ADDENDUM NO. 3
June 6, 2023

2023 RECONSTRUCT TERMINAL BUILDING
AIP No. 3-27-0025-20-2023
SKY HARBOR AIRPORT
DULUTH, MN

This addendum consists of 2 pages and Drawing Nos. G2.10, C3.00, C4.00, C5.01, A301, S101, S502, and S504.

GRADING PLAN (AIRSIDE
SLAB & SLOPED WALKWAY)

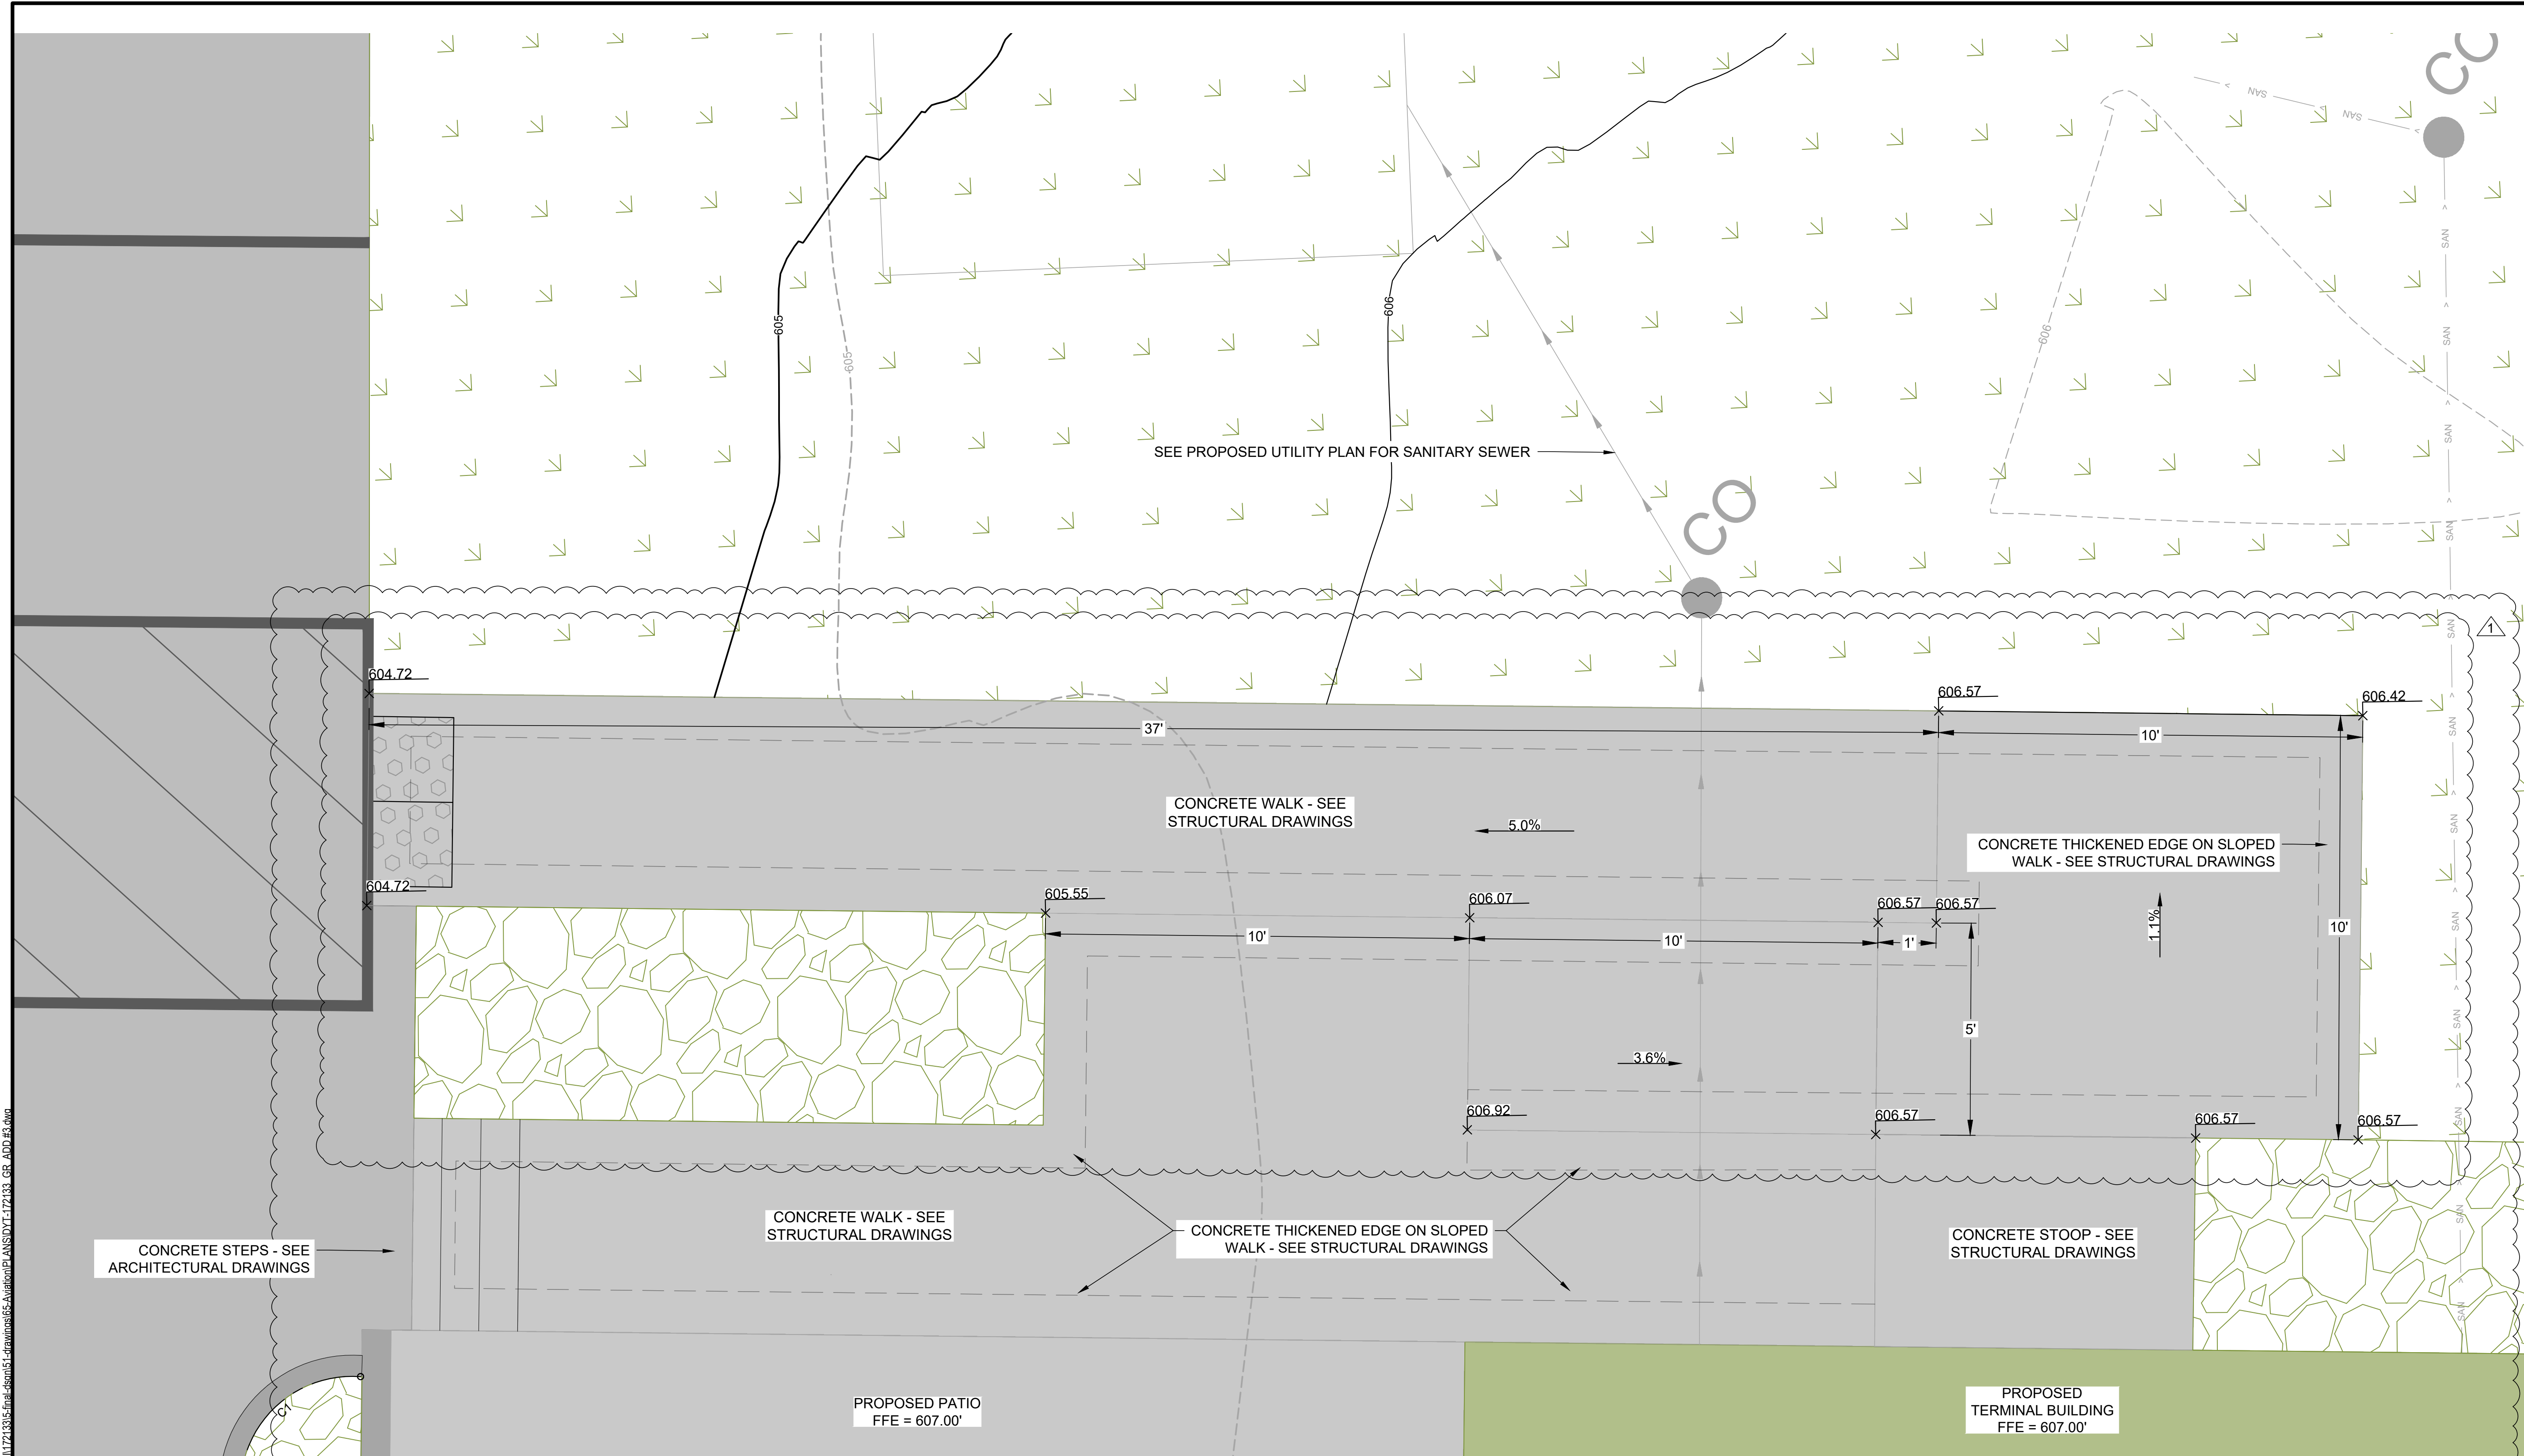
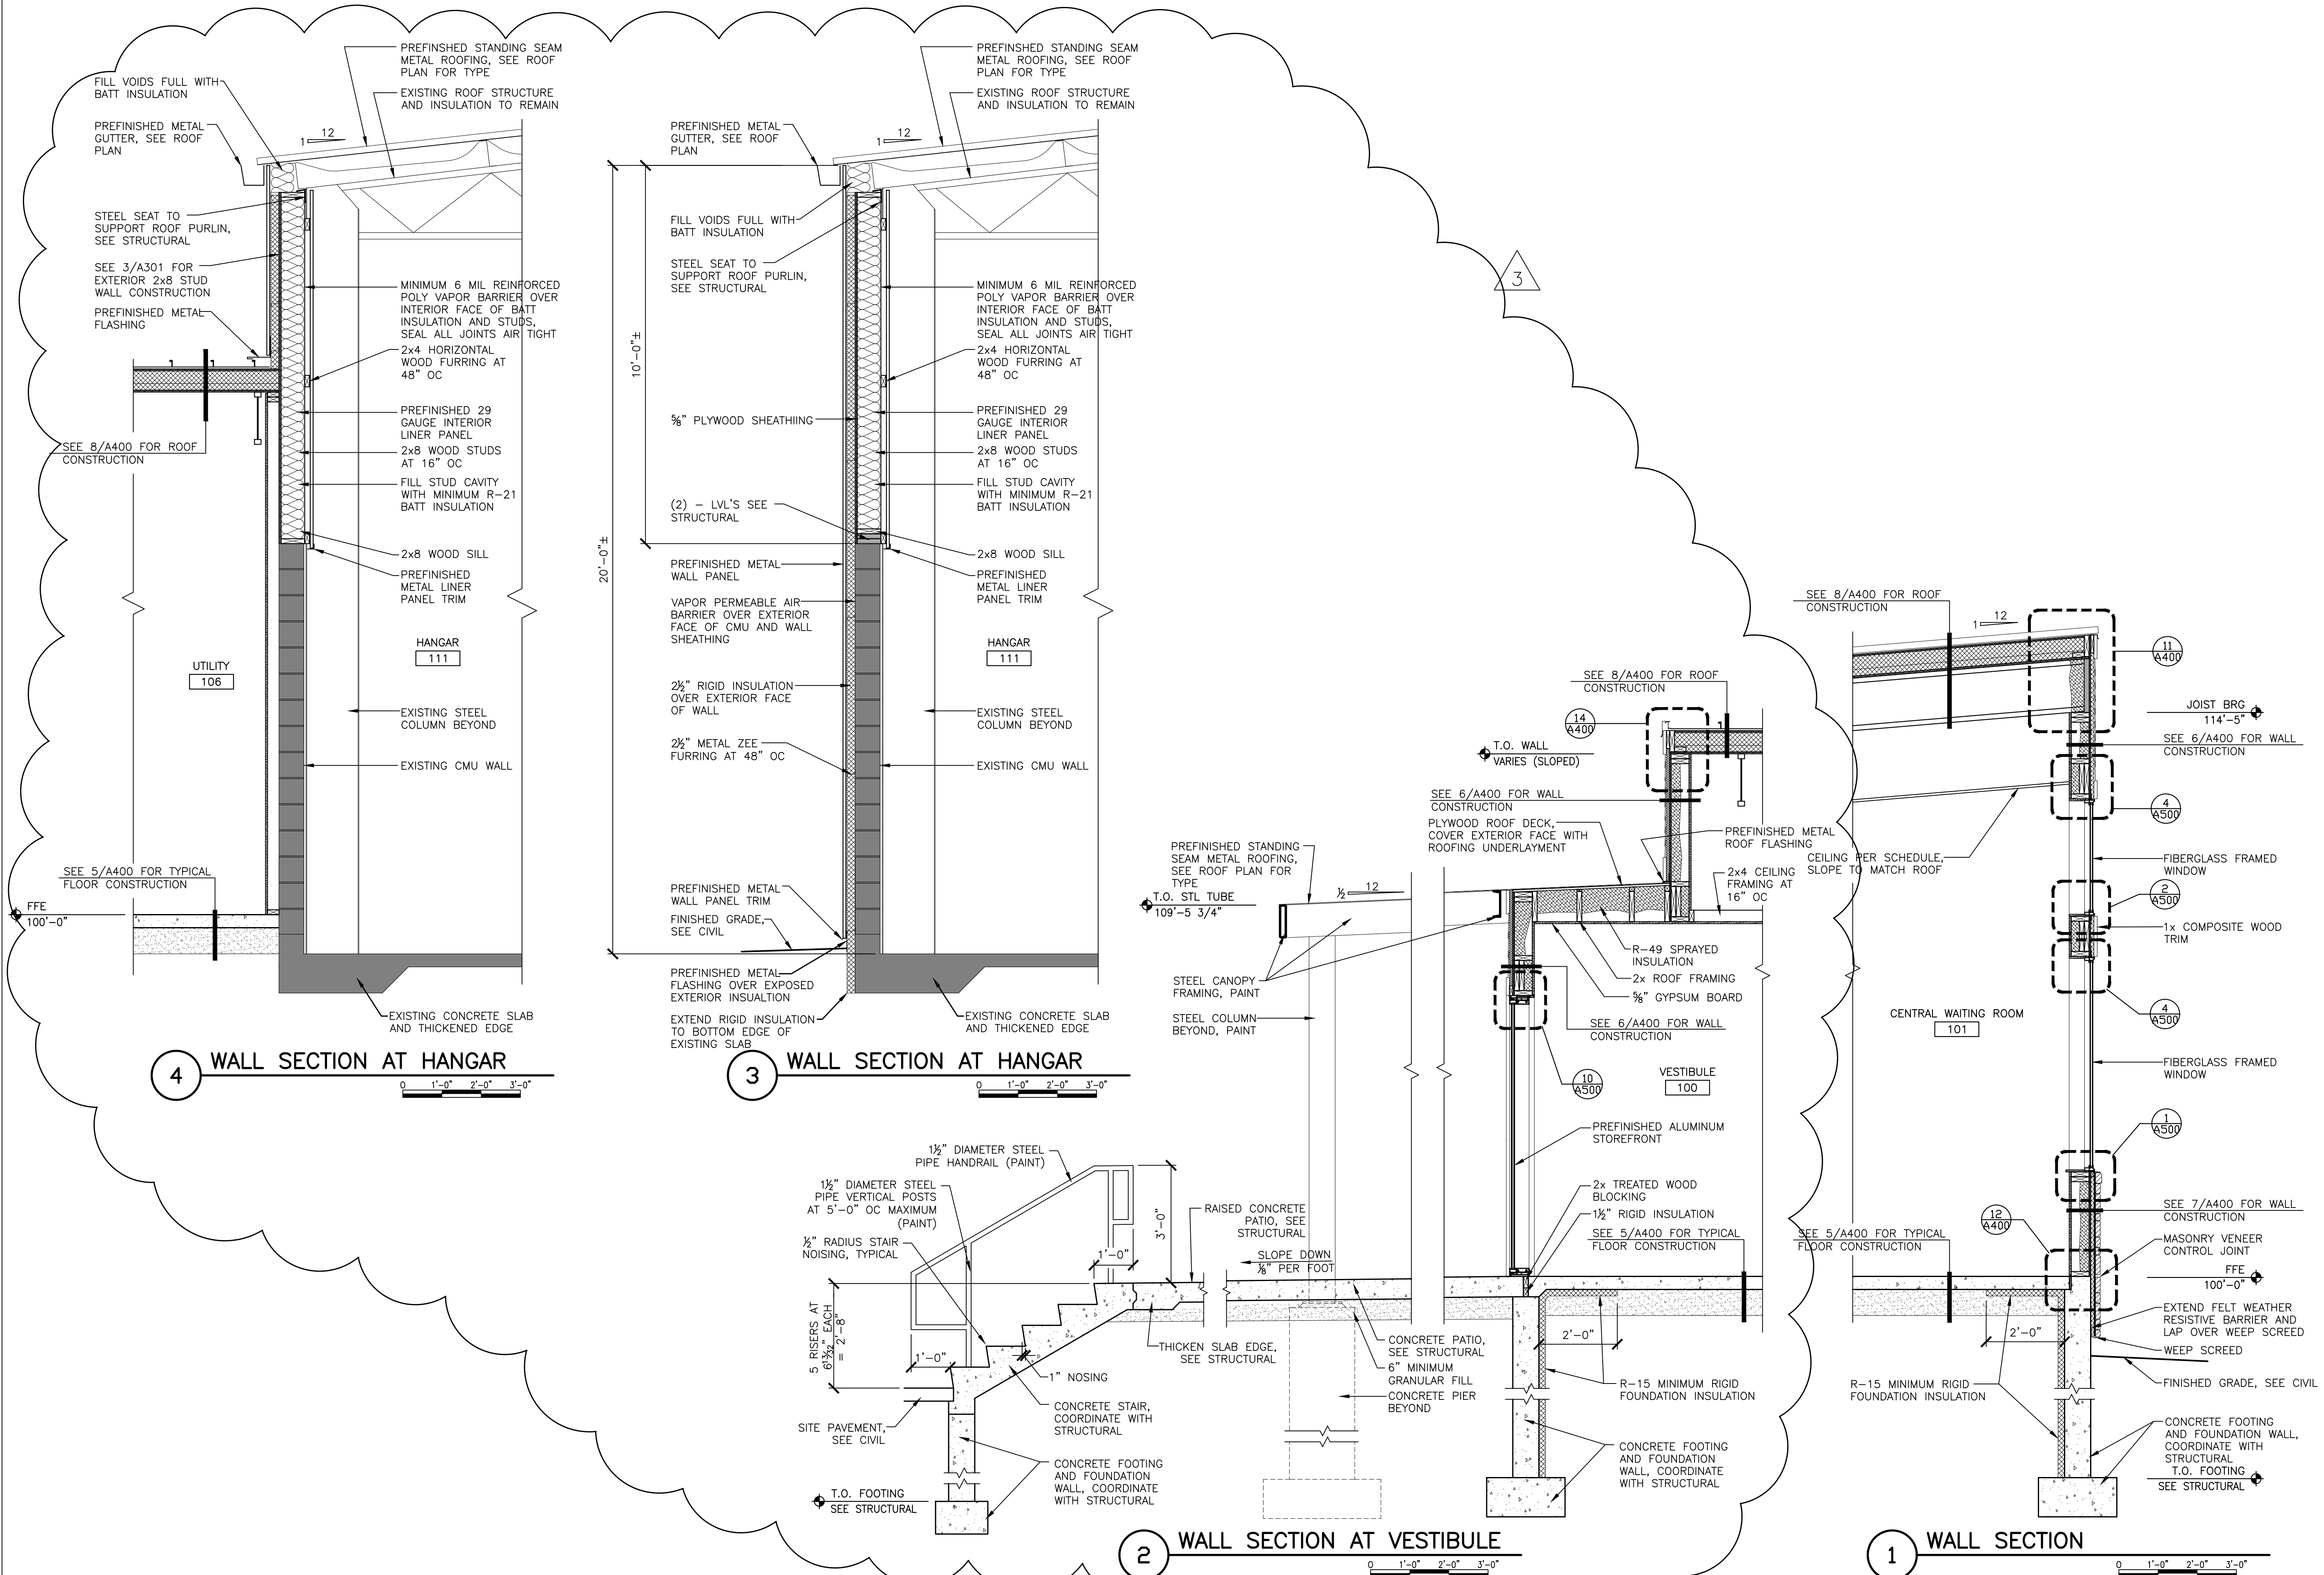
4. Drawing C5.01 – Grading Plan, DELETE in its entirety and REPLACE with the attached revised drawing.
 - Revised pavement plan limits for concrete walk, related to structural drawings. Northside sloped walk will be covered under structural and building construction item.

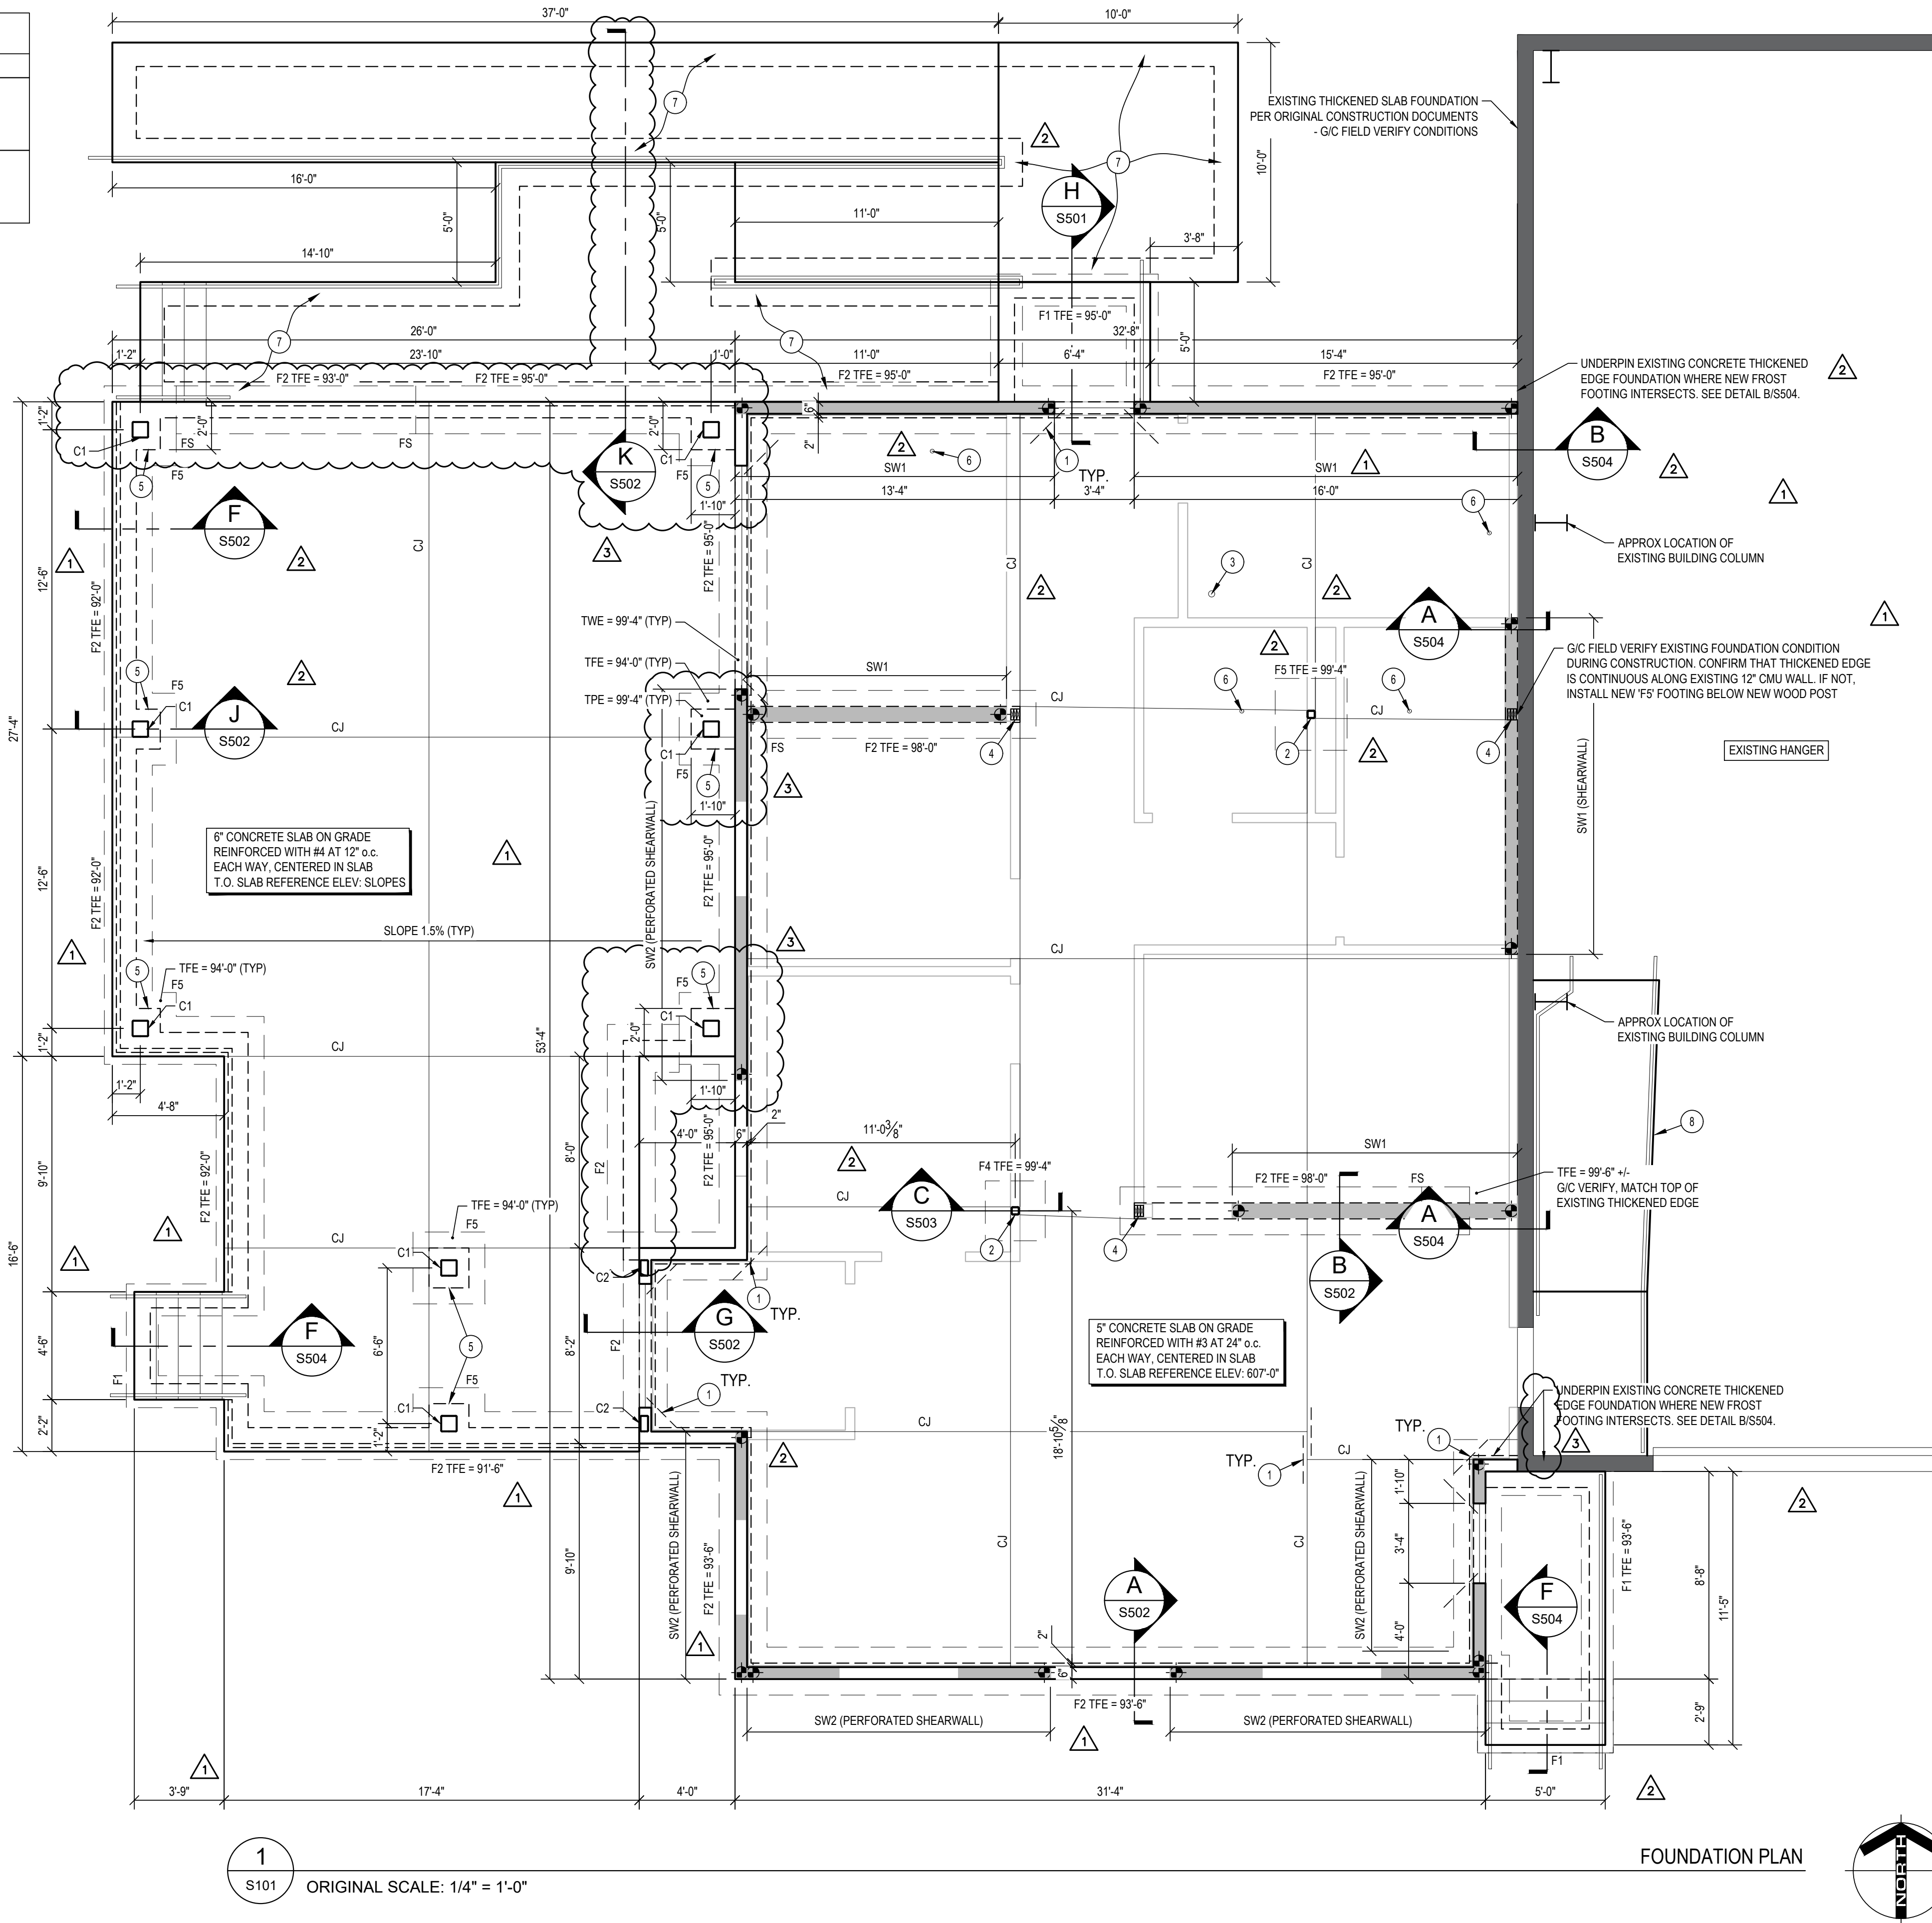
5. DELETE the following drawings and REPLACE in their entirety with the attached revised drawings:
 - A301, S101, S502, and S504.
 - i. Added detail related to thickened edge for sloped walk on northside of building.

(8) #6 REBAR VERTICAL
#3 TIES AT 12" OC PLUS (3) AT 2" OC AT TOP
- FLOOR DRAIN - SEE MECHANICAL DRAWINGS.
- 6" CONCRETE RAMP AND STAIR ON GRADE. REINFORCE WITH #4 REBAR AT 12" OC EW. PROVIDE MIN. 12" WIDE THICKENED EDGES AT ALL EDGES OF RAMP AND AT HEIGHT TRANSITIONS. THICKENED EDGE SHALL EXTEND MIN. 12" BELOW ADJACENT FINISHED GRADE OR AT TOP OF SLAB, WHICHEVER IS LOWER. REINFORCE THICKENED EDGE WITH (2) #5 REBAR TOP AND BOTTOM. SEE DETAIL K/S502.
